January 22, 2024

Re: Hamilton-Wenham Regional High School Athletic Campus Redevelopment  
Site Plan Review Application and Stormwater Management Permit Application –  
Response to Comments  
Gale JN 718601

Table with 2 columns: DRAWING NO., G002. Row 2: 2 OF 33

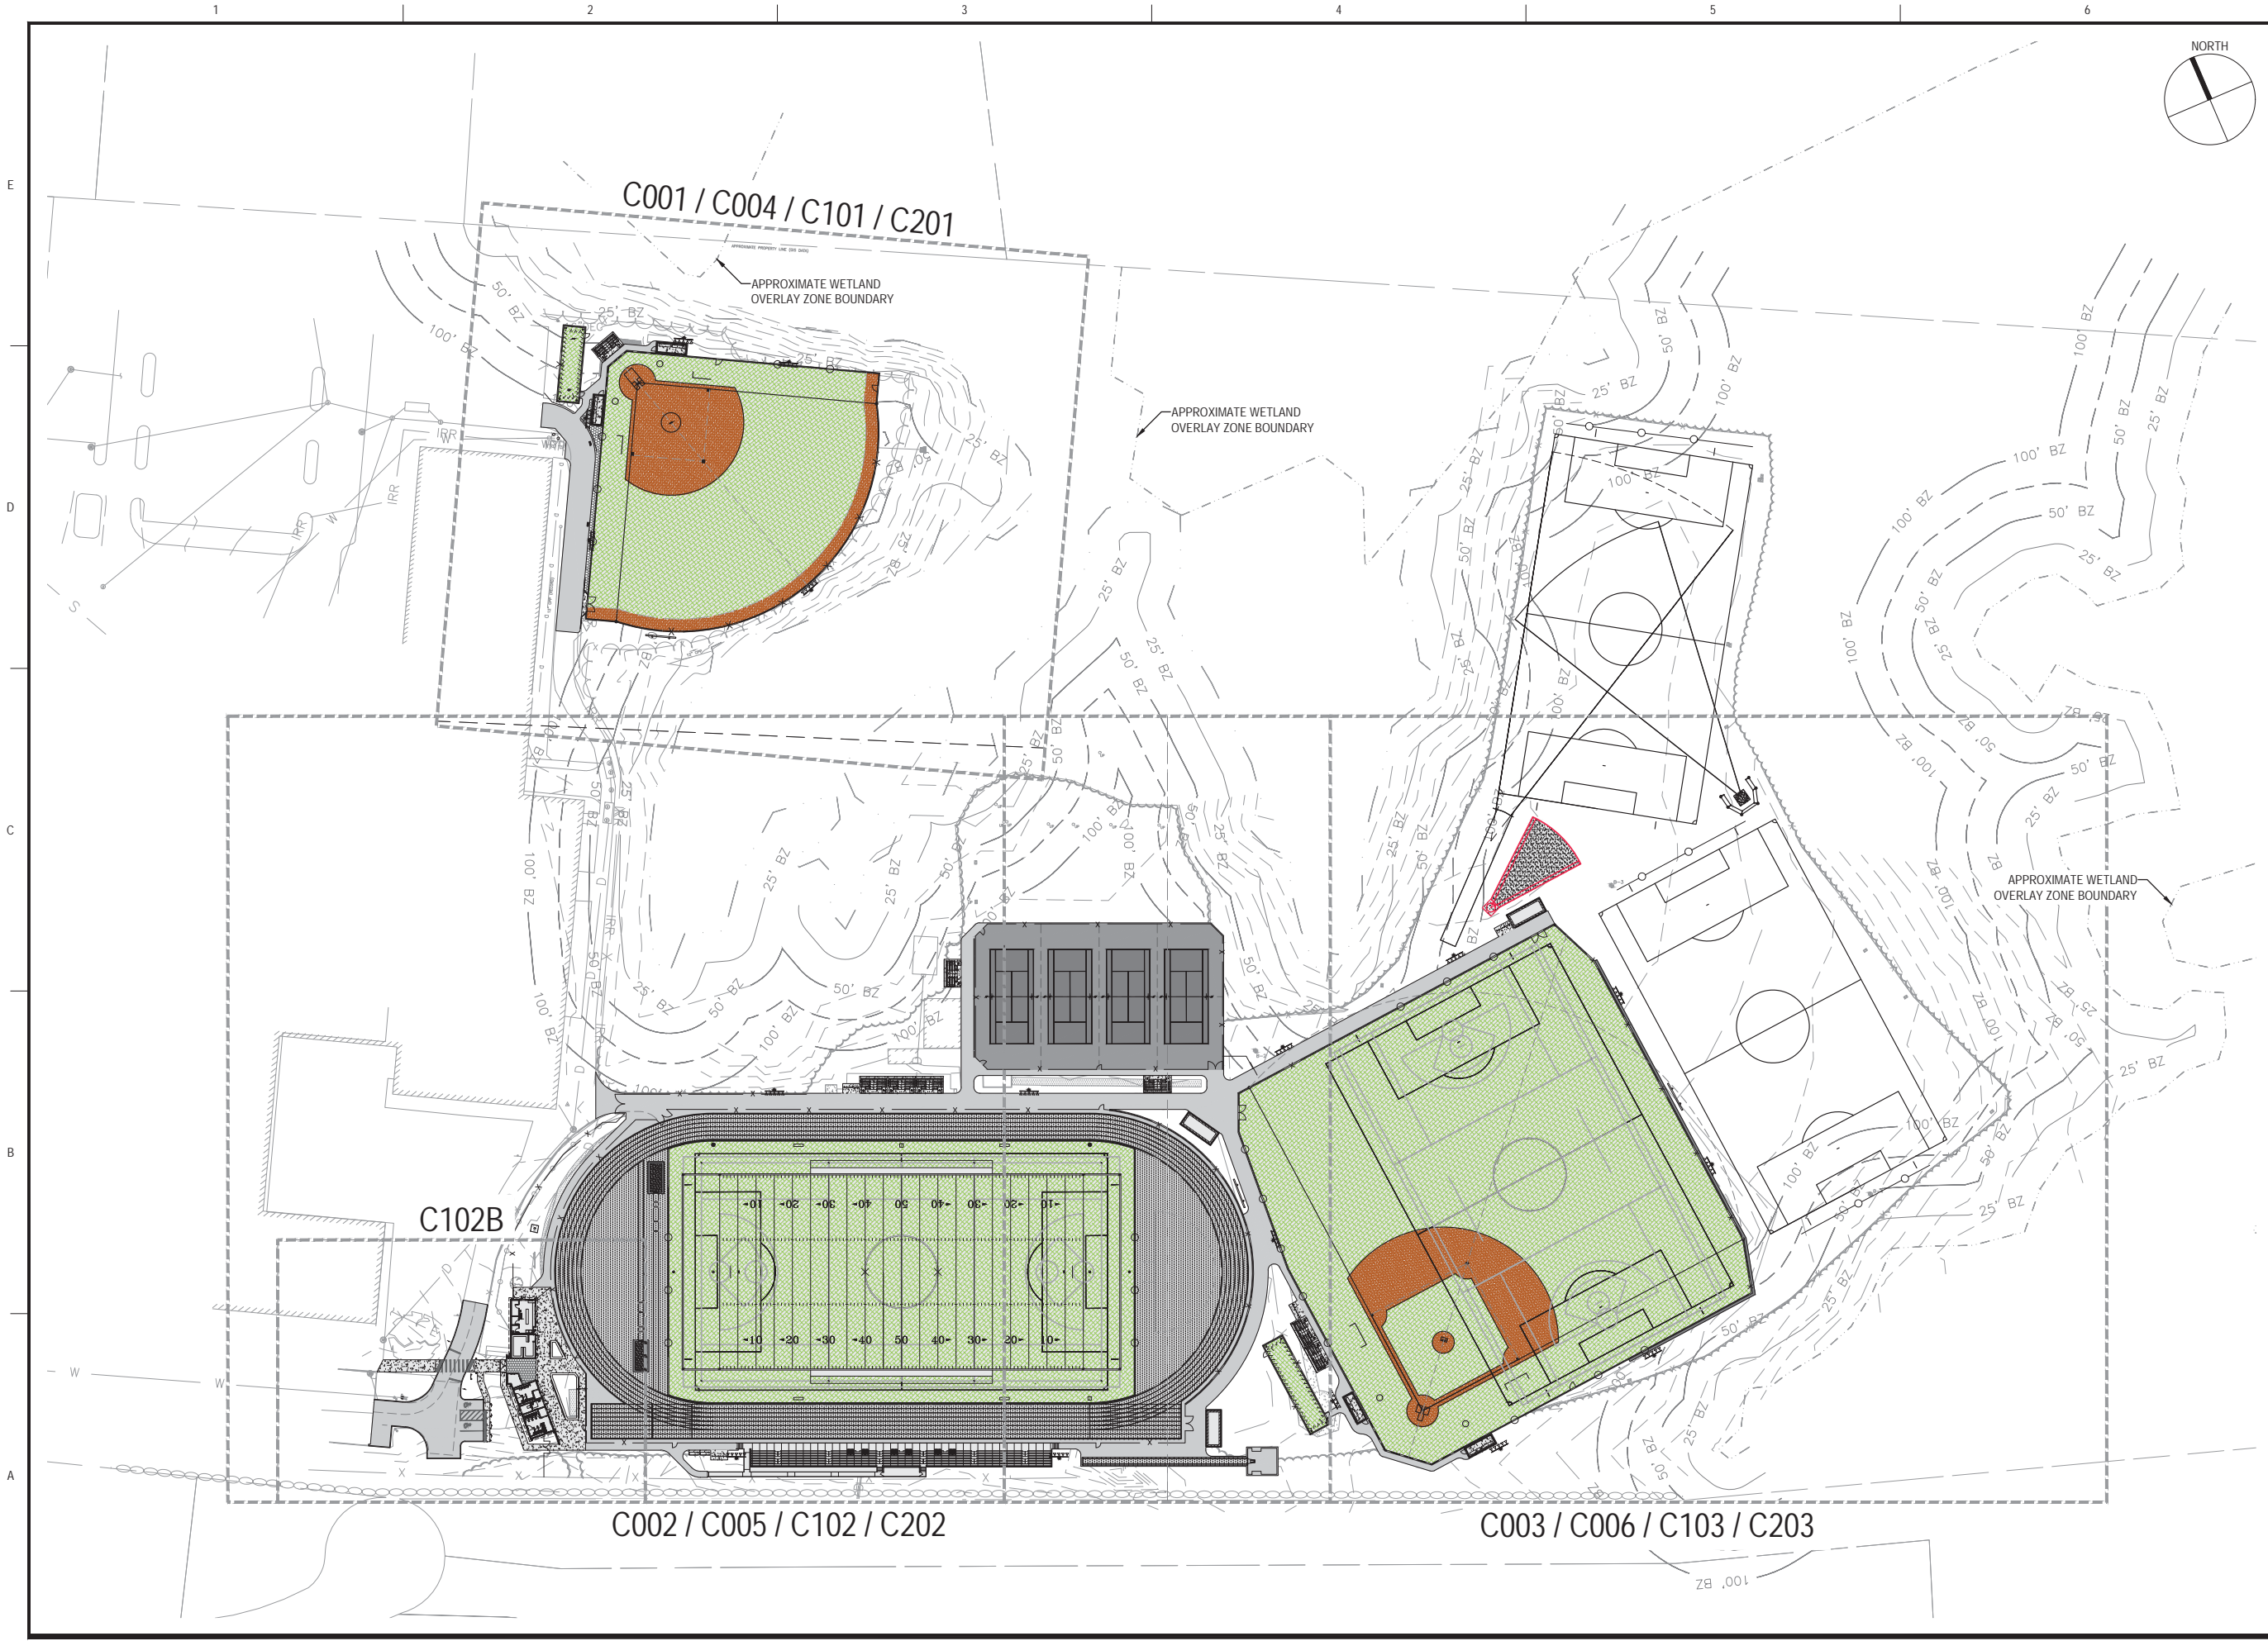
**33. Work hours including deliveries and on-site engine warmup and idling shall comply with the School District's requirements and further shall be limited to 7:00 AM to 5:00 PM on weekdays with no work on Sunday or legal holidays.**

**34. Mark the limit of work with high visibility temporary fencing.**

**35. Provide convenient sanitary facilities and trash collection containers. Remove any litter or waste two times per week or more frequently if required.**

**36. Due to proximity of wetlands, dust control should be limited to the application of mist using potable water.**

Response: This note has been added to the plans, refer to Plan Sheet G002.

Response: As noted at the hearing on January 9, 2024, the limit of work on the plans is depicted by the limit of the silt sock. Temporary construction fencing has been added to the plans. Refer to the Plan Sheet G002 for "Construction General Notes" addressing the limit of work and construction fencing.

Response: This note has been added to the plans, refer to Plan Sheet G002. Also note that this is covered in Gale's standard clean-up and protection specification sections.

Response: This note has been added to the plans; refer to Plan Sheet G002.
